AS-BUILT PLAN REVISIONS
BY Roy A. Galli DATE 12-18-89
RCE 16024
ADD LOC DIMS FOR 8 MILE AND
QUASHNICK RD ON 18" S.D. INLET DET.
ADDED SHEETS 28A & 28B

MORADA ESTATES NORTH
SAN JOAQUIN COUNTY

STREET IMPROVEMENT PLANS: MORADA ESTATES NORTH

TYPICAL (2 SITES)
PRESSURE TANK & PUMP SITE PLAN
SCALE: 1" = 10'

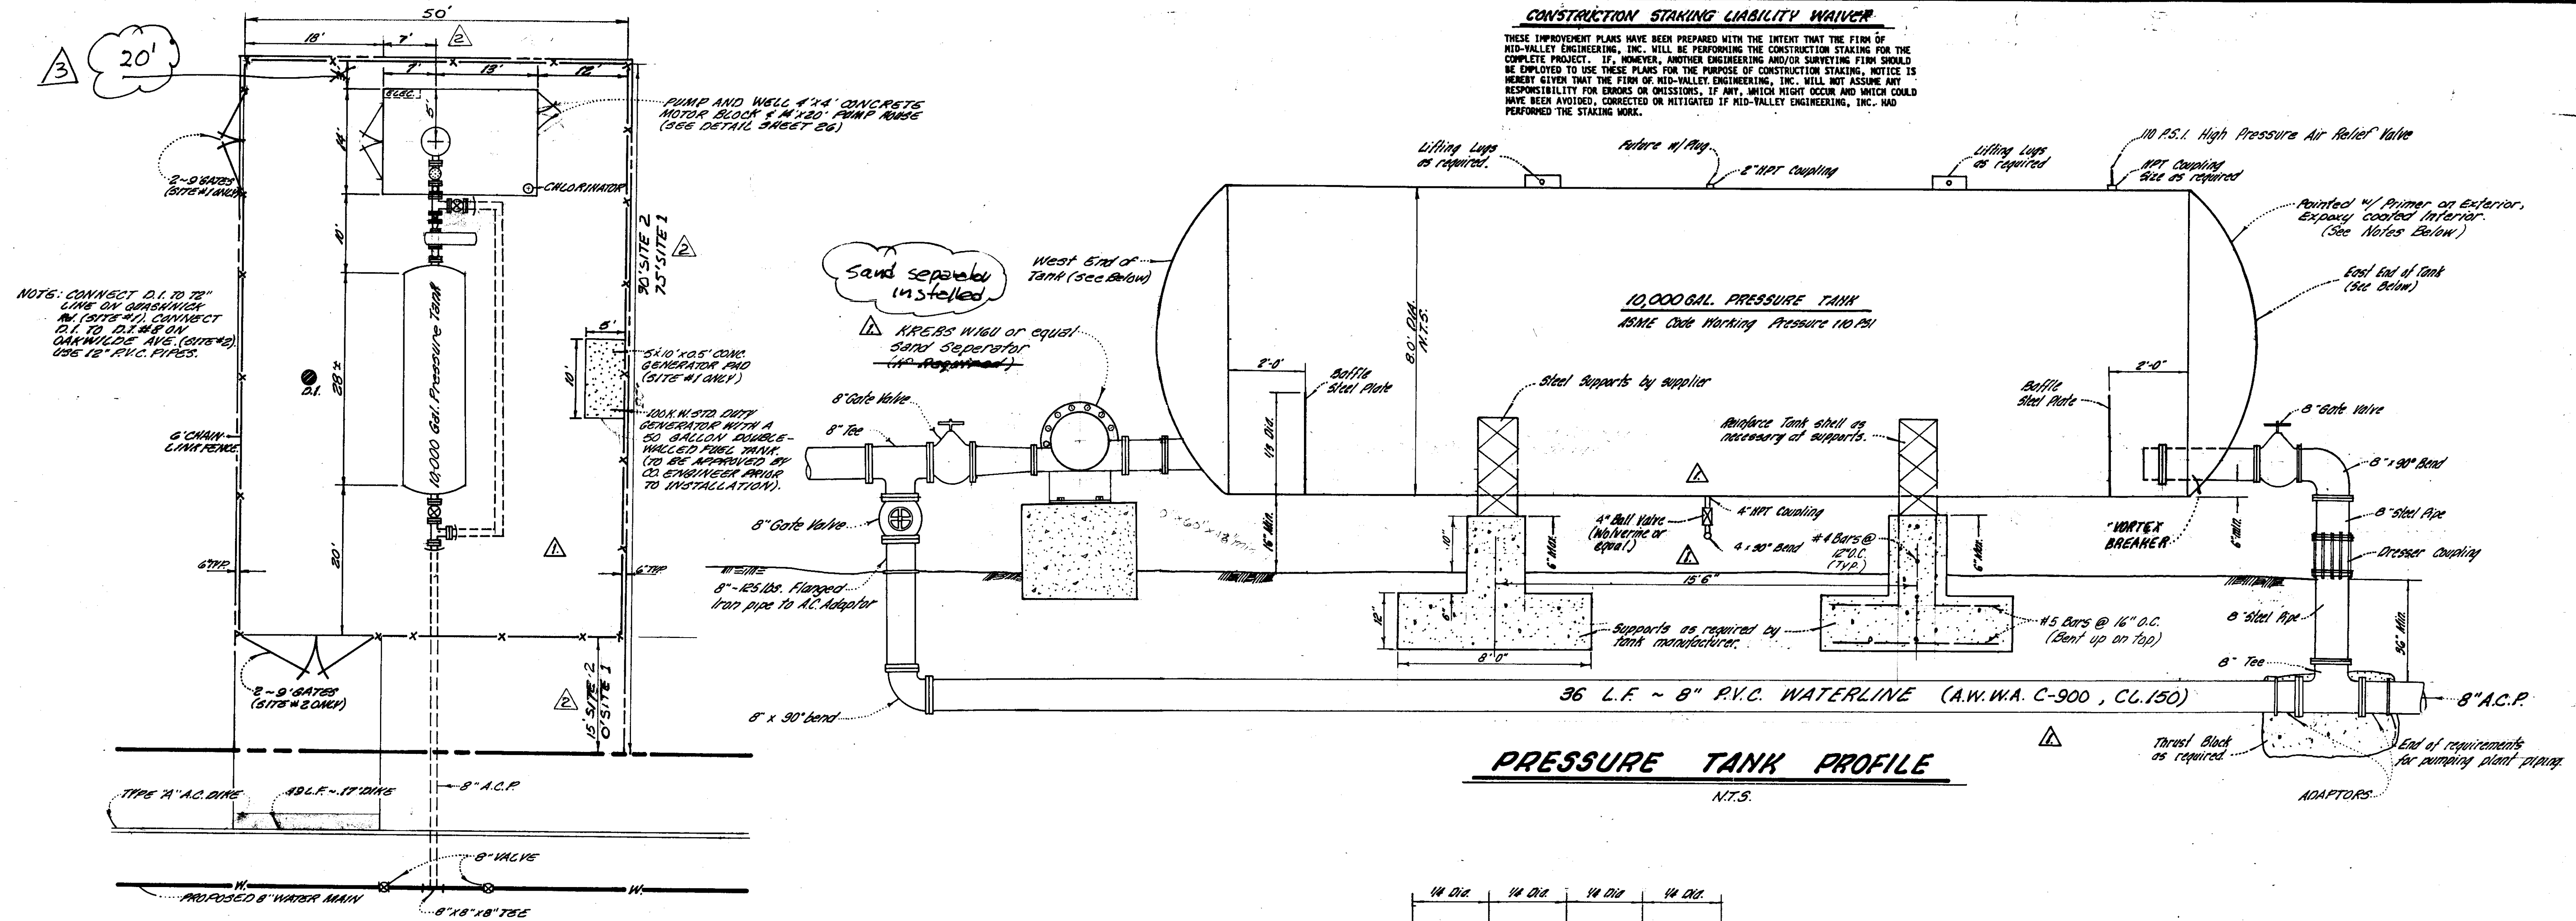
BY: [Signature]	DATE: 12-18-89
RCE 16024	
ADDED DIMS TO PUMP SITE	
PLAN	
Well 25' From R.

PLAN AND PROFILE
STORM DRAIN DISCHARGE LINE / QUASHNICK RD.
MORADA ESTATES NORTH
SAN JOAQUIN COUNTY

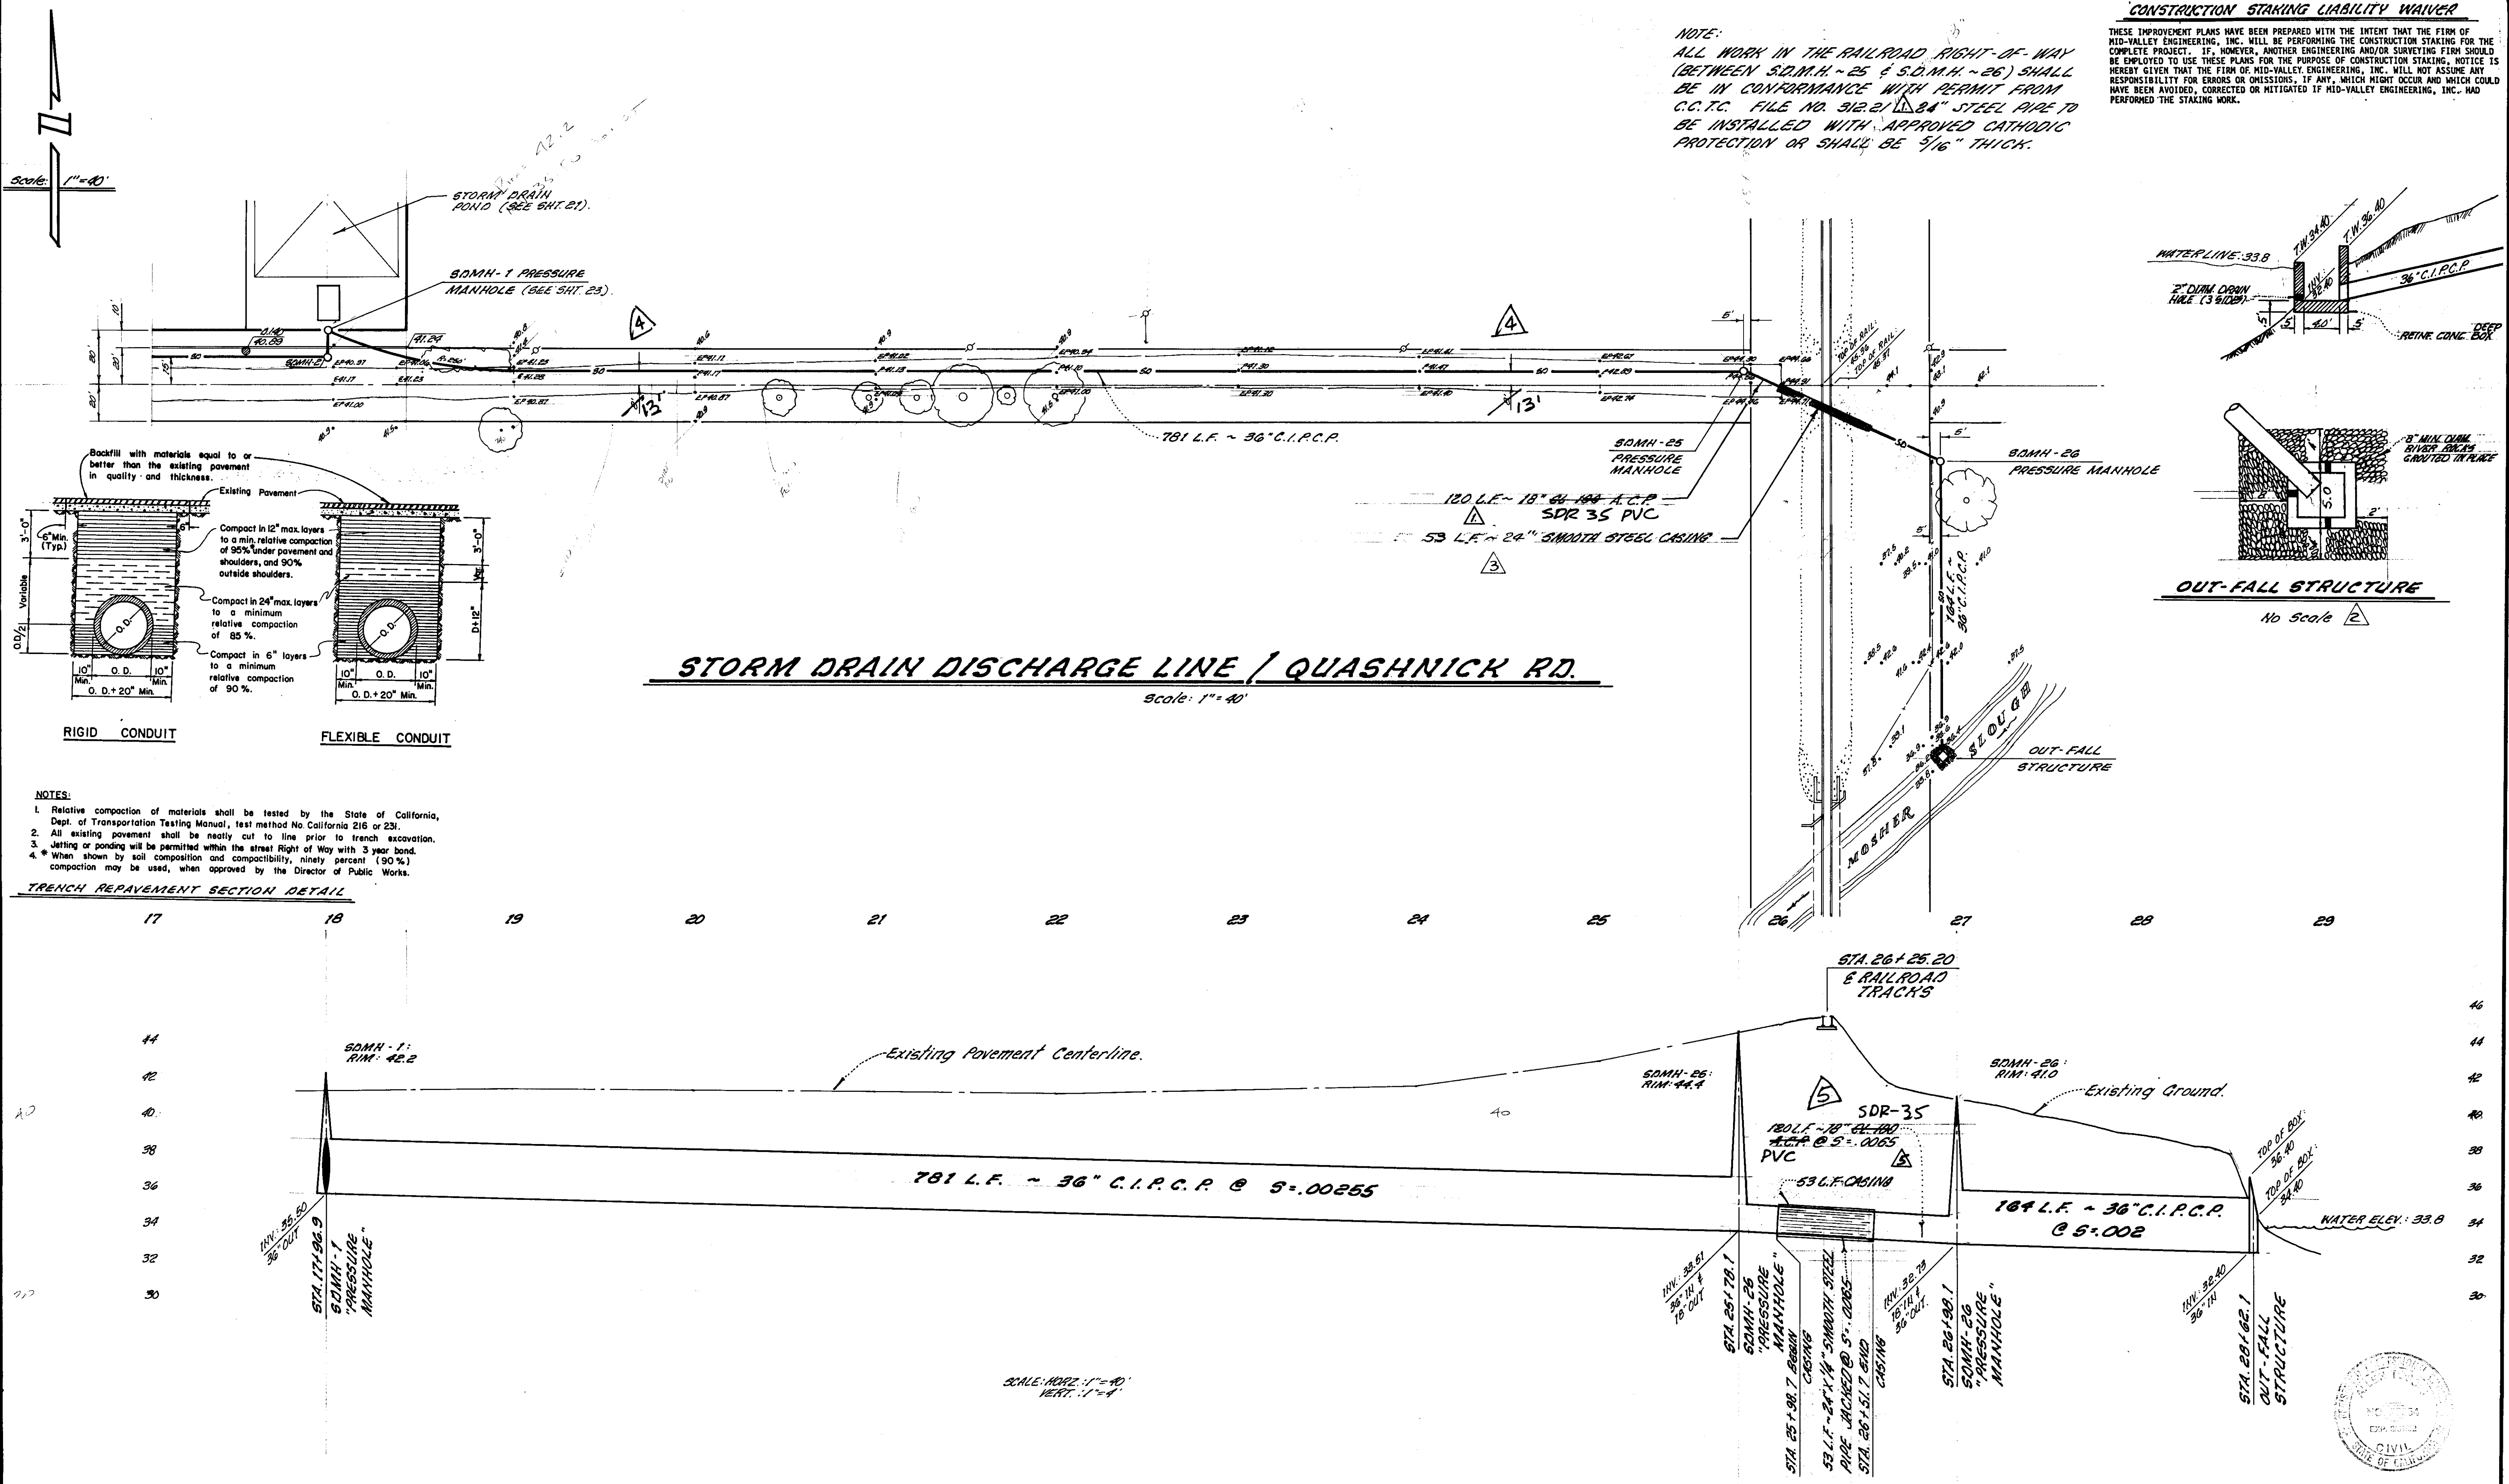
AS-BUILT PLAN REVISIONS
BY Jim A. Galli DATE 12-18-89
RCE 16024
REV. FALL-OUT DETAIL
REV. 1/4" DIM FROM 24" PIPE & LENGTHEN
PIPE DWG TO TRUE LGTH.
ST. DRN LINE MOVED TO 13' N of &
material change in R/R KING PIPE

TRASH RACK - TYPICAL SECTION
Scale: 1" = 1'
(12 SECTIONS TOTAL)

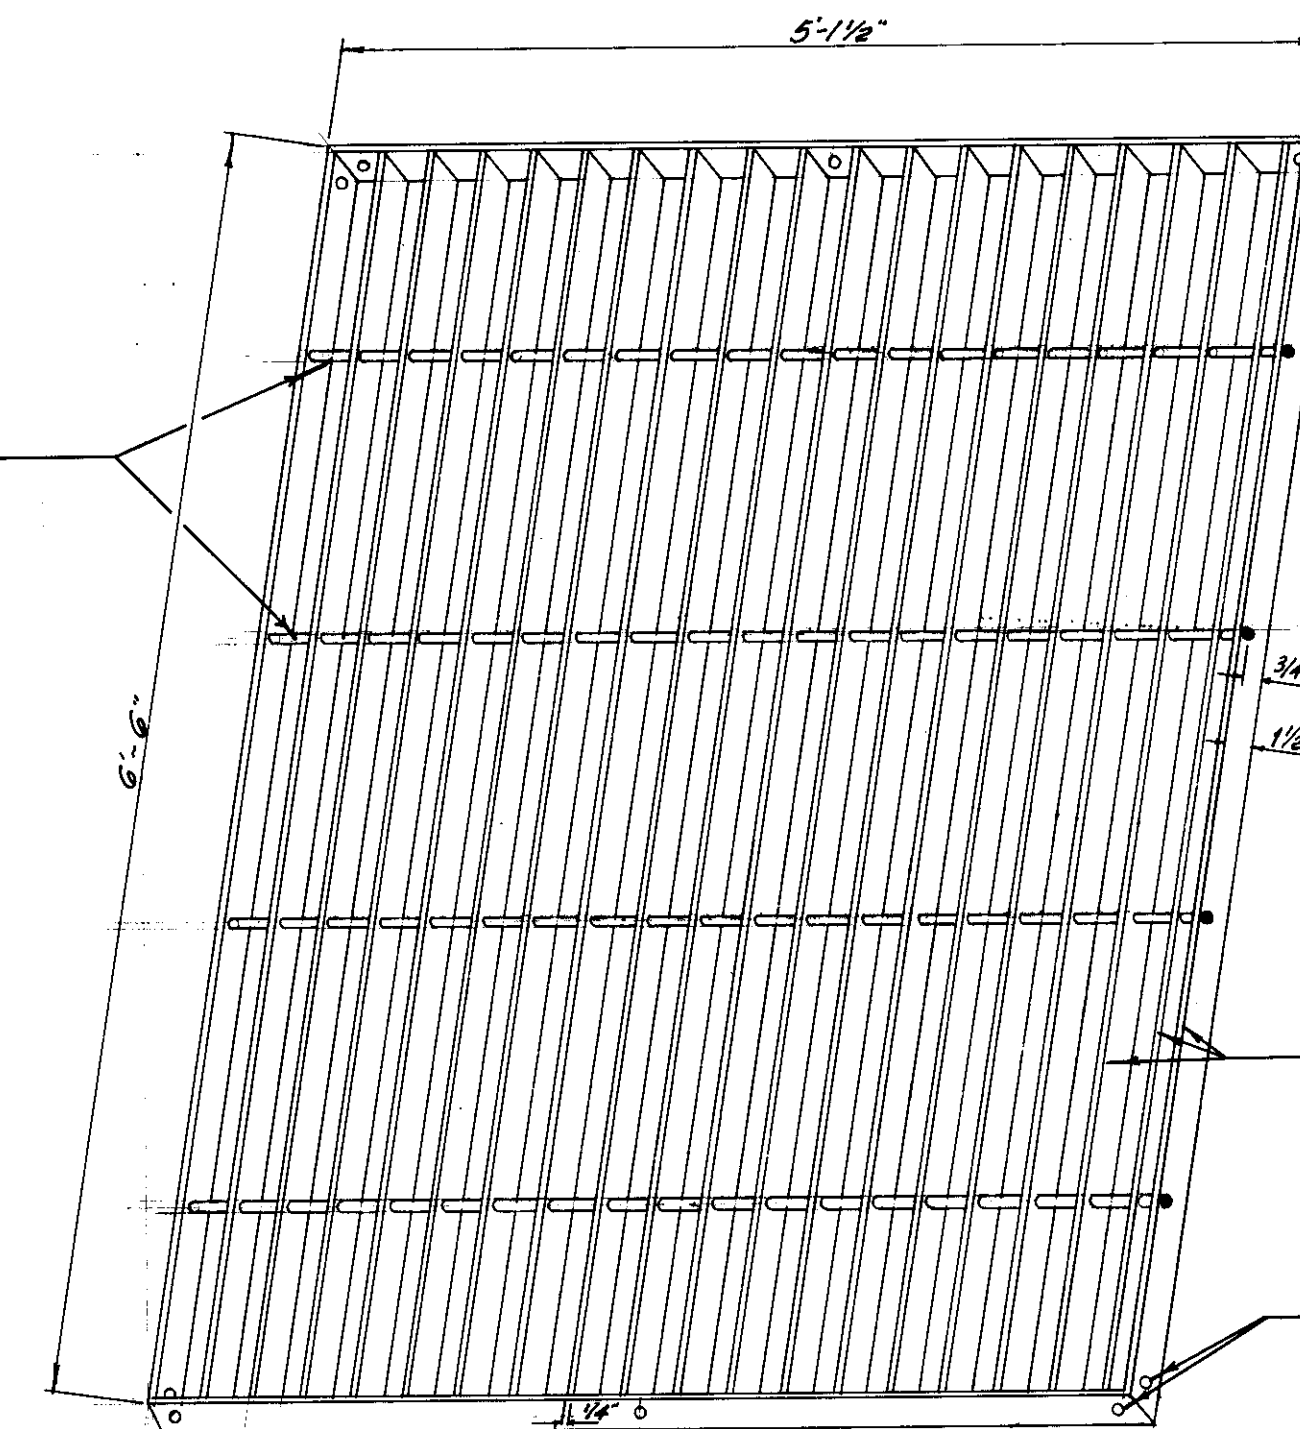
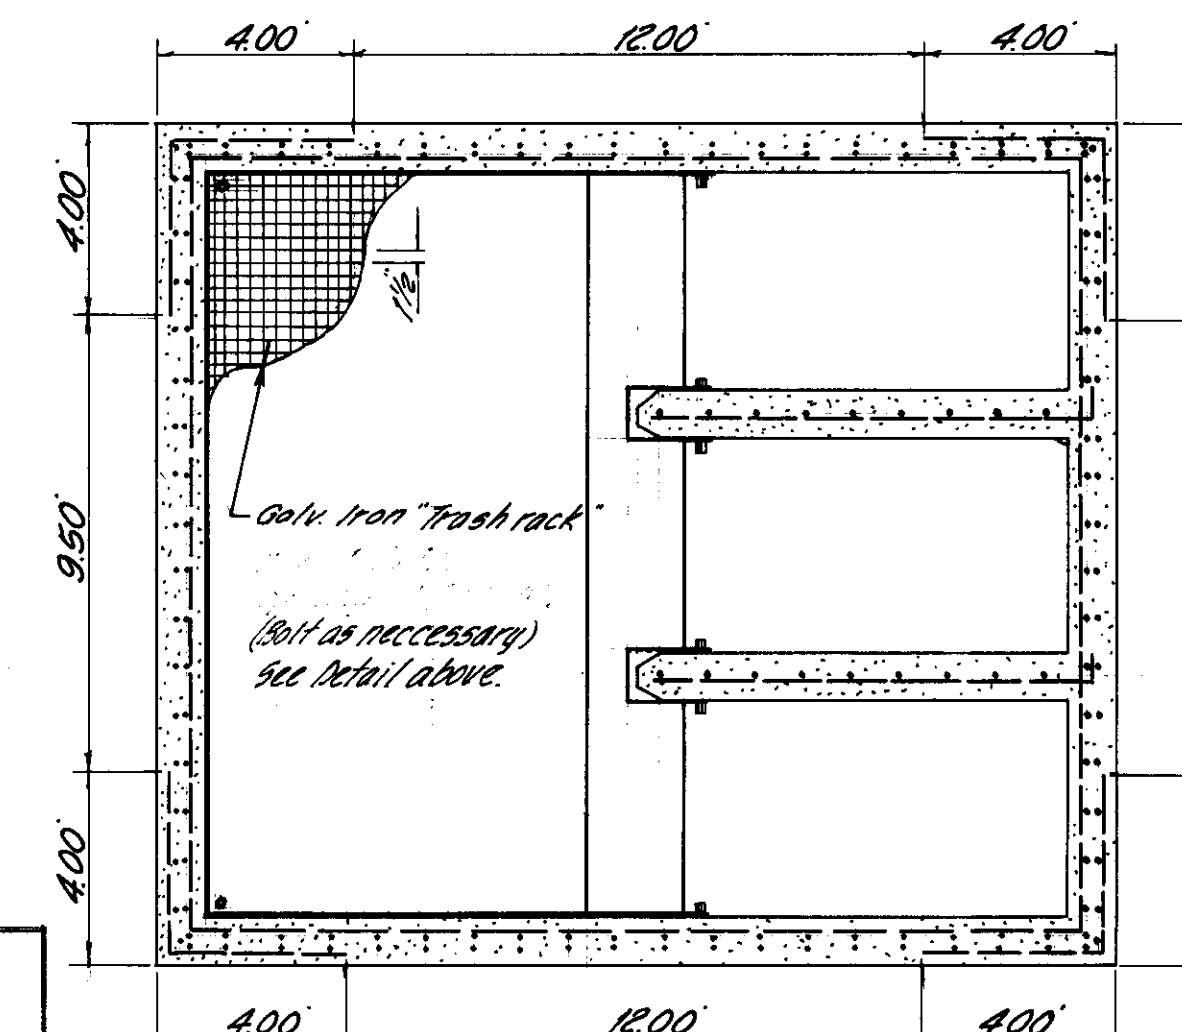
AS-BUILT PLAN REVISIONS	
BY <i>Roy A. Galli</i>	DATE 12-18-89
RCE16024	
REV. TRASH RACK TO VERT. POS.

PLAN AND PROFILE
QUASHNICK ROAD
EL GRECO DRIVE
MORADA ESTATES NORTH
SAN JOAQUIN COUNTY

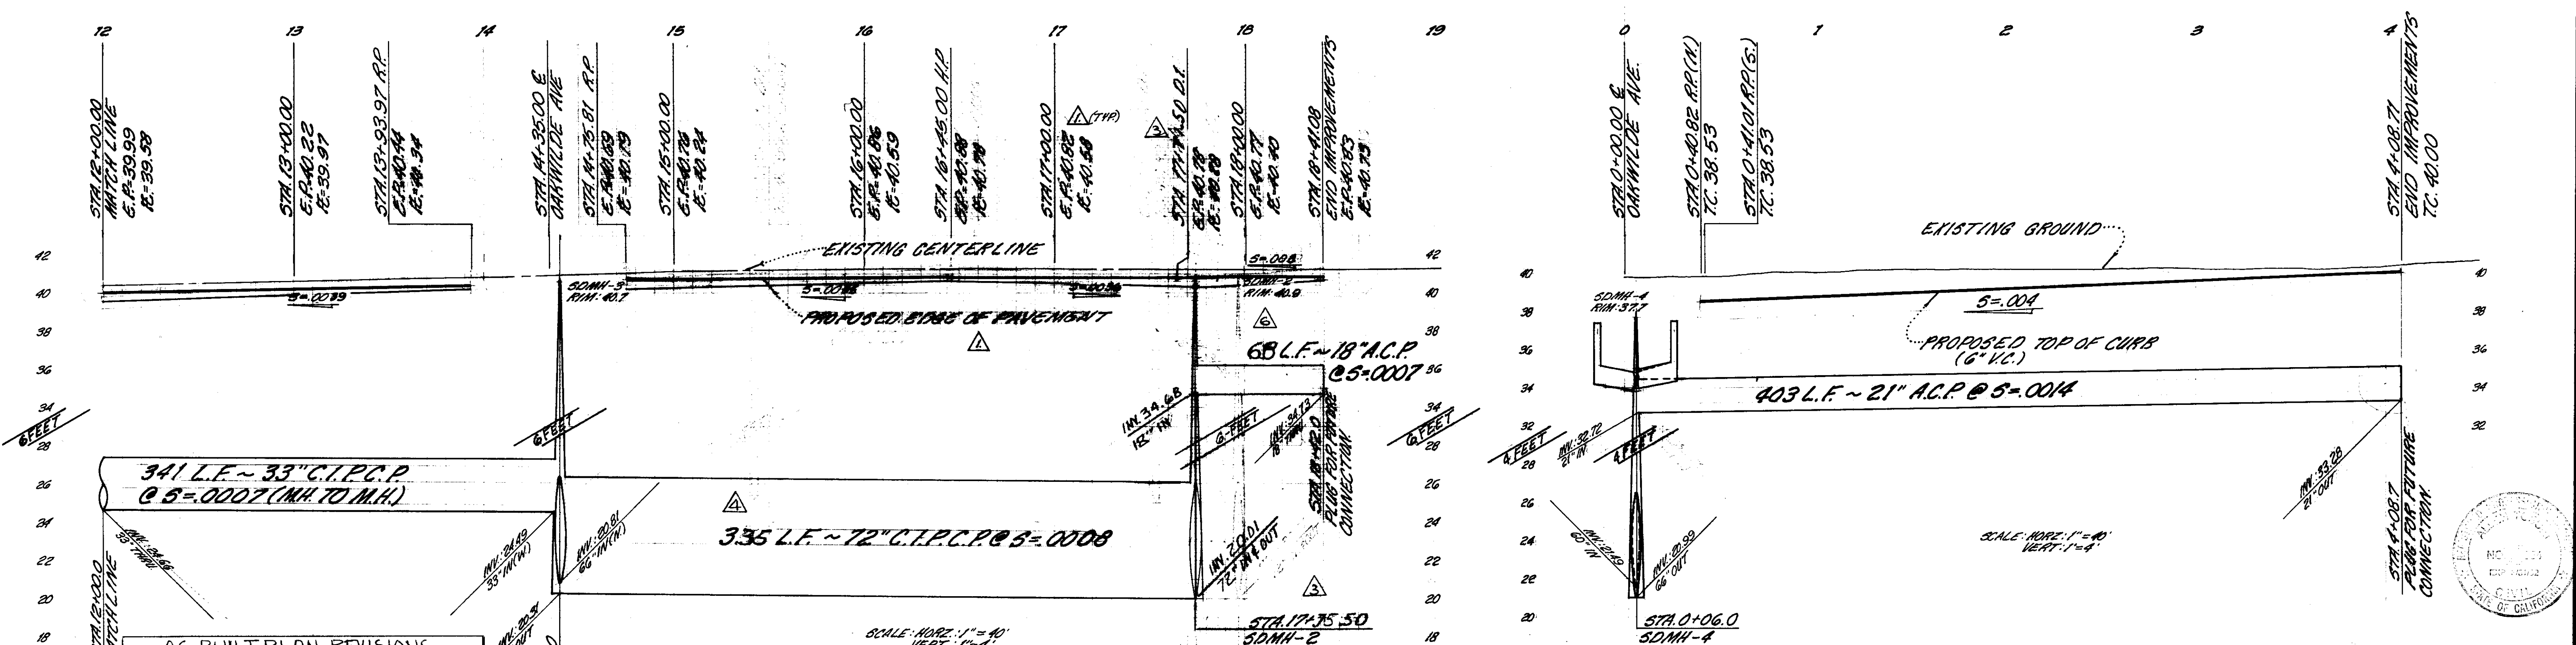
2. REVISE LOT NO'S
3. RELOCATE M.H. 1 & 2 & C.B. & STA. NO'S
4. REV. 72" CLIPCD LGTH TO 335 LF. (WAS 356)
5. ENLARGE & MOVE POND & PUMP STA.
6. REV. 18" PIPE LGTH TO 68' TO MATCH STA.
